Rezoning Application: RZ PD 26-0328 (Rev. 4-28-26)

Zoning Hearing Master Date: April 27, 2026

Introduction Summary

AGENCY REVIEW COMMENT SHEET

Exhibit B - Site Plan

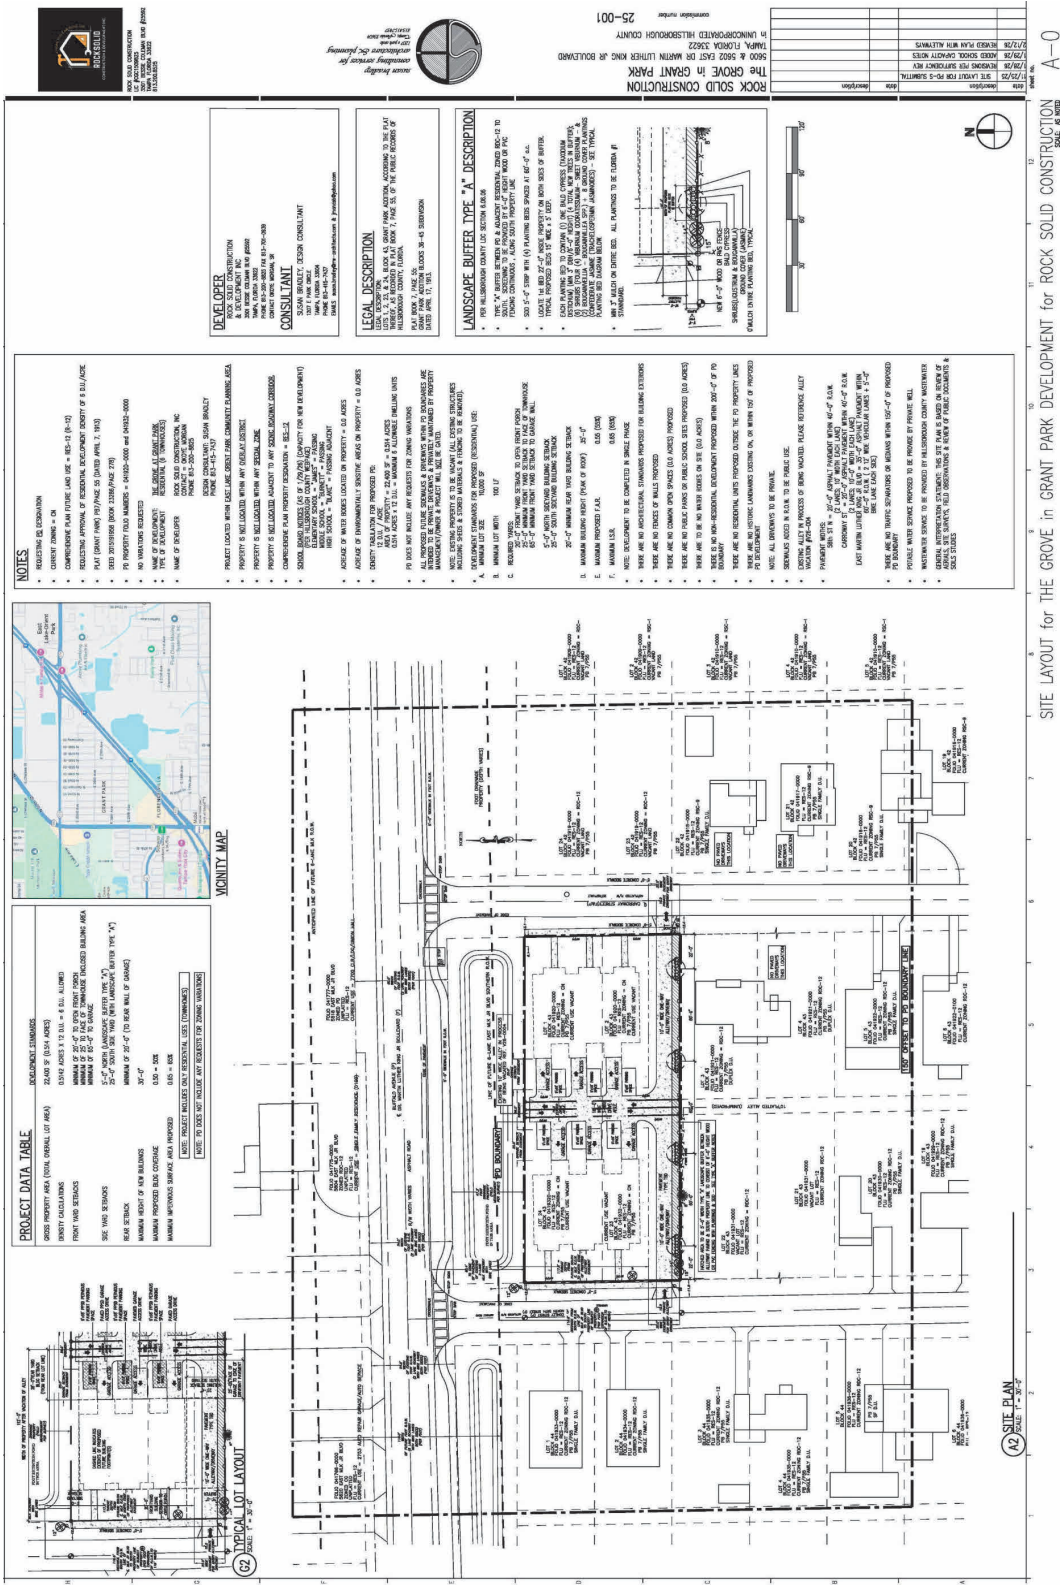
- Section 6.04.07 to provide access on N 58th Street to the proposed development.
 - The proposed driveway location does not meet Hillsborough County minimum spacing requirements.

The proposed one-way alley is essential for both access to the site and internal circulation.

Therefore, the proposed access location is necessary for the proposed development and, without a variance, reasonable access cannot be provided to the site.

Exhibit B - Site Plan

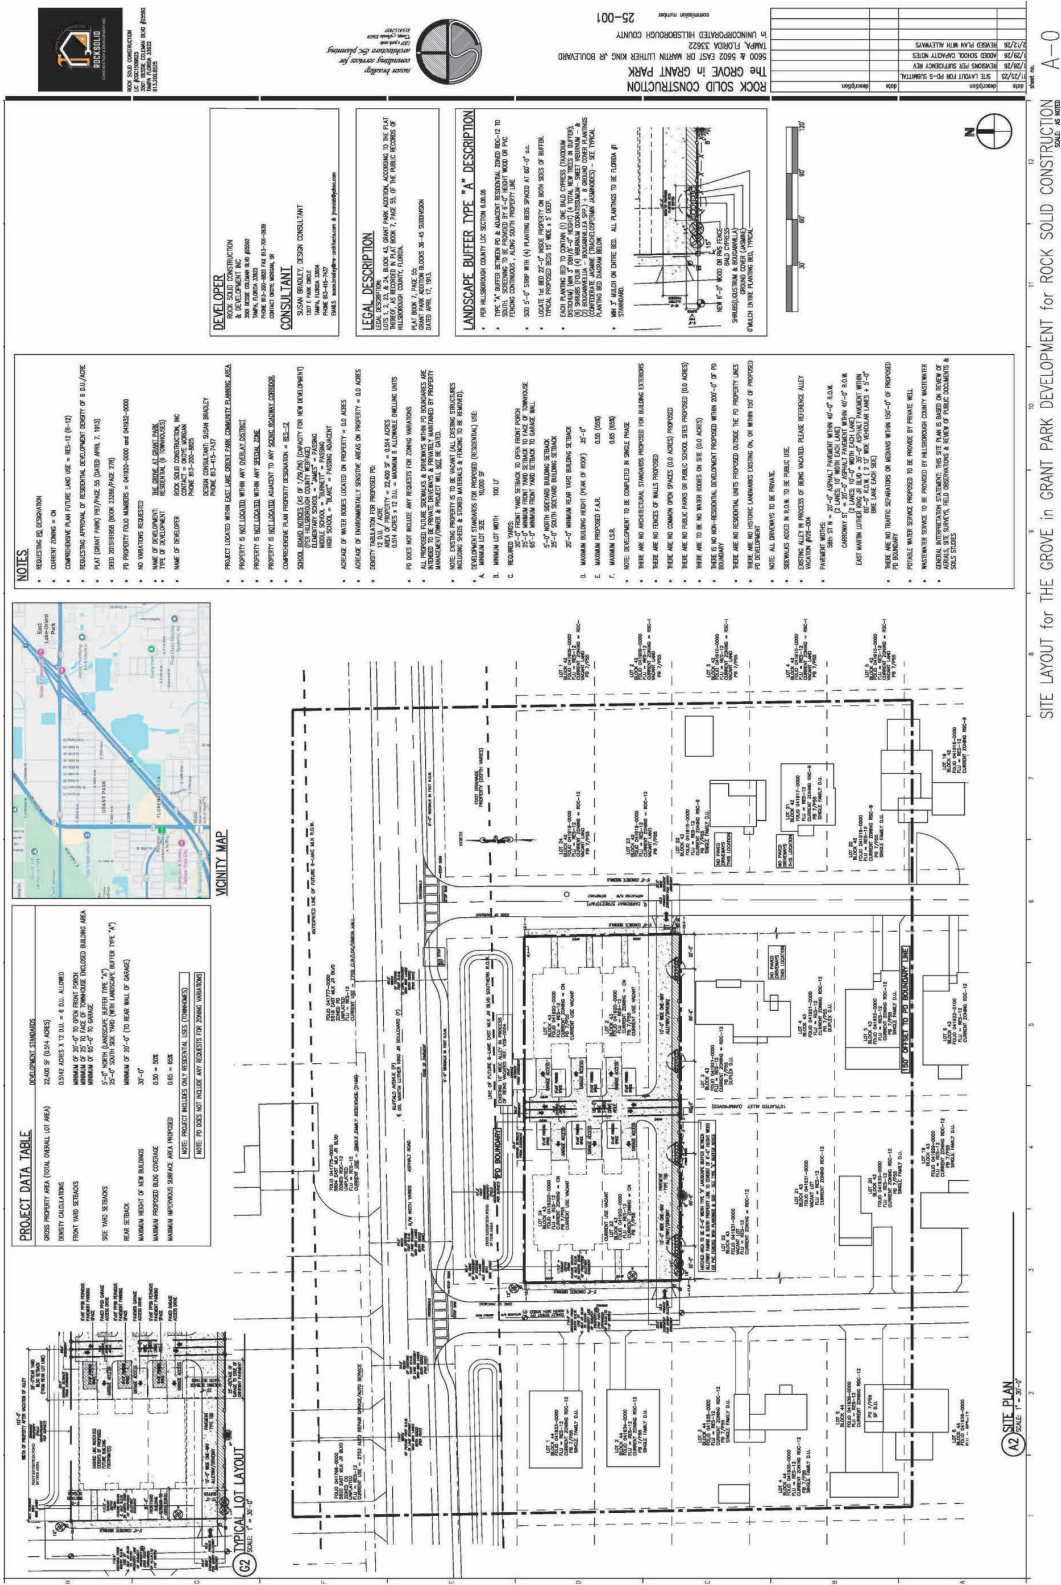
- Section 6.04.07 to provide access on N 58th Street to the proposed development.
 - The proposed driveway location does not meet Hillsborough County minimum spacing requirements.

The proposed one-way alley is essential for both access to the site and internal circulation.

Therefore, the proposed access location is necessary for the proposed development and, without a variance, reasonable access cannot be provided to the site.
